The follow drawing, see attached your exhibit E
and F of report.

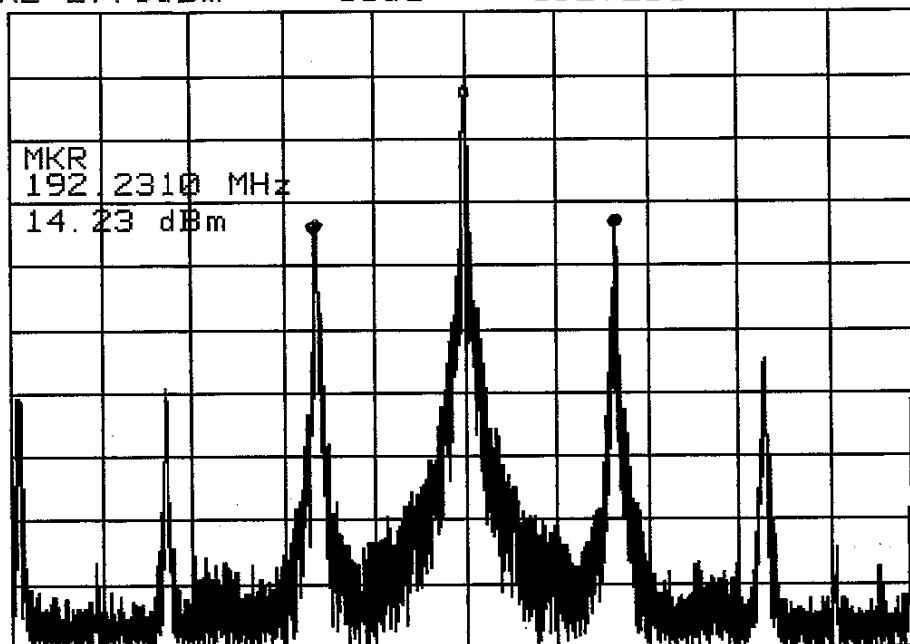
This chart
included pilo
with 37.768kHz
tone frequency
when unmodulat

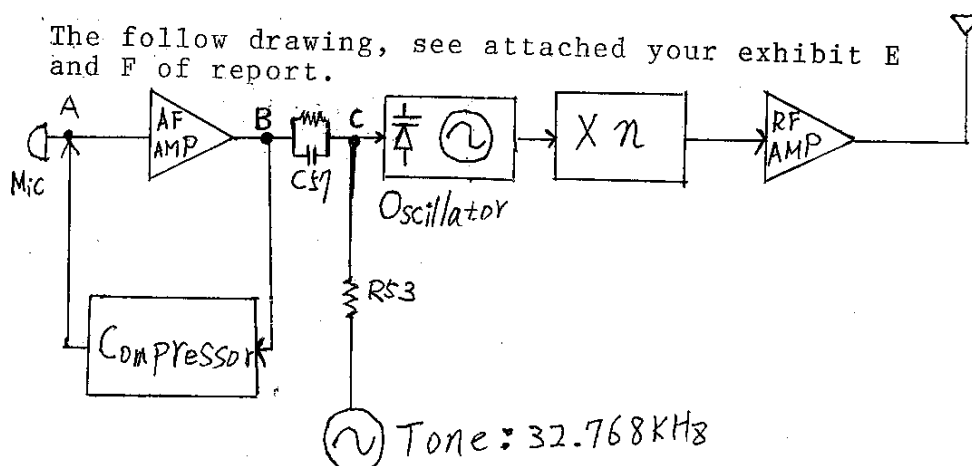
- mark A: Input 13kHz signal bu signal generator.
mark B: Producted 13KHz and its harmonic. (For example 13kHz, 26kHz and so on)
mark C The 13kHz and all harmoic frequencypilot with 32.768kHz tone frequency.

13kHz Sinewave input at Mic point (PAGE 1 Block DIAGRAM)

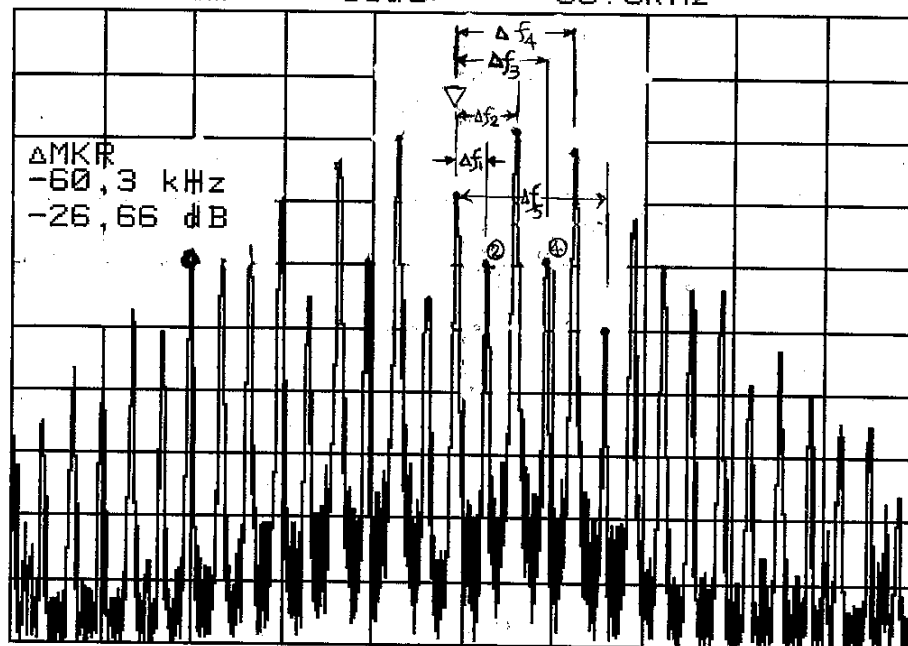
$$\Delta f_1 = 6.768\text{kHz} \quad (13\text{kHz } 2^{\text{nd}} \text{ harmonic pilot with } 32.768\text{kHz Tone})$$

$$32.768\text{kHz} - 26\text{kHz} = 6.768\text{kHz}$$

$$\Delta f_2 = 13\text{kHz} \quad (\text{Input Sinewave fundamental})$$

$$\Delta f_3 = 19.768\text{kHz} \quad (13\text{kHz Pilot with } 32.768\text{kHz Tone})$$

$$32.768\text{kHz} - 13\text{kHz} = 19.768\text{kHz}$$

$$\Delta f_4 = 26\text{kHz} \quad (13\text{kHz second Harmonic})$$

$$\Delta f_5 = 32.768\text{kHz} \quad (\text{pilot Tone})$$

② and ④ mark identify the spectral component as your E-mail
